**Technical Service
Information Bulletin**

Title:
INSTRUMENT PANEL RATTLE
Models:
'06 GS 300, GS 430, & '07 GS 450h

NVH
NV004-06

Introduction Some customers may complain of rattle noises coming from the front of the instrument panel at the base of the windshield. The following procedures have been developed to improve this condition.

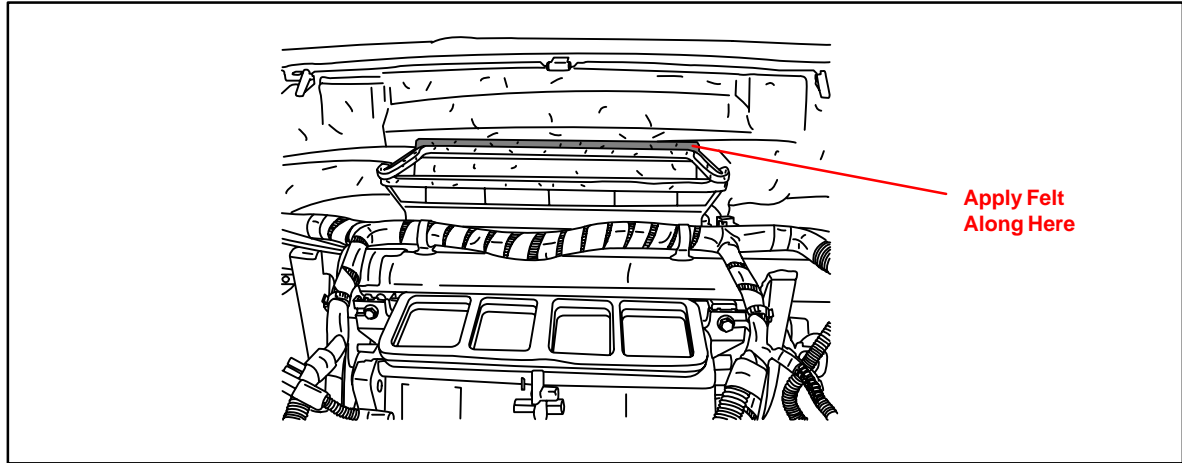
1. Remove the instrument panel sub-assembly.
Refer to the Technical Information System (TIS), applicable model and model year Repair Manual: *Instrument Panel: Instrument Panel Safety Pad: Removal*.
2. Remove the instrument panel sub-assembly to expose the instrument panel attachment clips.
3. Remove the instrument panel attachment clips and apply two (2) felt squares to the cowl side attachment points as shown in the following illustration.

Felt Size:**Length: 10 mm (0.39 in.)****Width: 10 mm (0.39 in.)****Thickness: 0.5 mm (0.02 in.)**

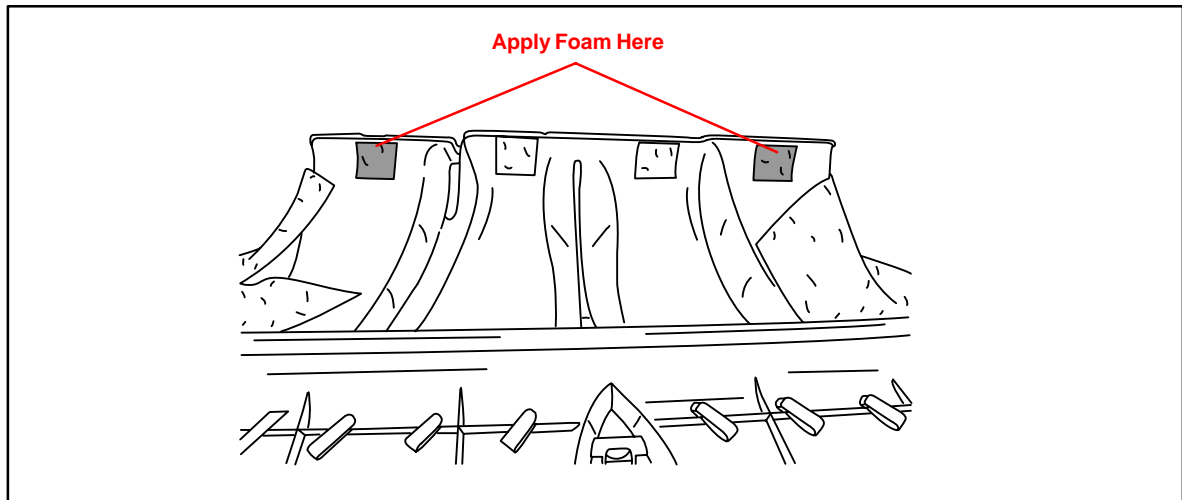
4. Apply felt along the defroster nozzle lip as shown in the following illustration.

Felt Size:

Length: 29 cm (11.42 in.)

Width: 14 mm (0.55 in.)

Thickness: 0.5 mm (0.02 in.)

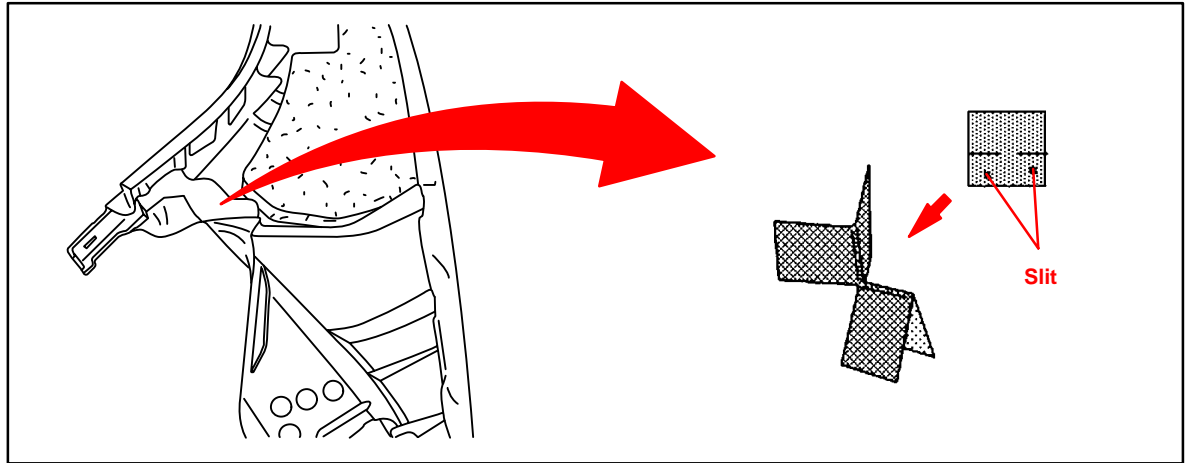
5. Apply foam to the instrument pad HVAC duct as shown in the following illustration.

Instrument panel pad is shown upside down.

Foam Size:

Length: 30 mm (1.18 in.)

Width: 30 mm (1.18 in.)

Thickness: 5 mm (0.20 in.)
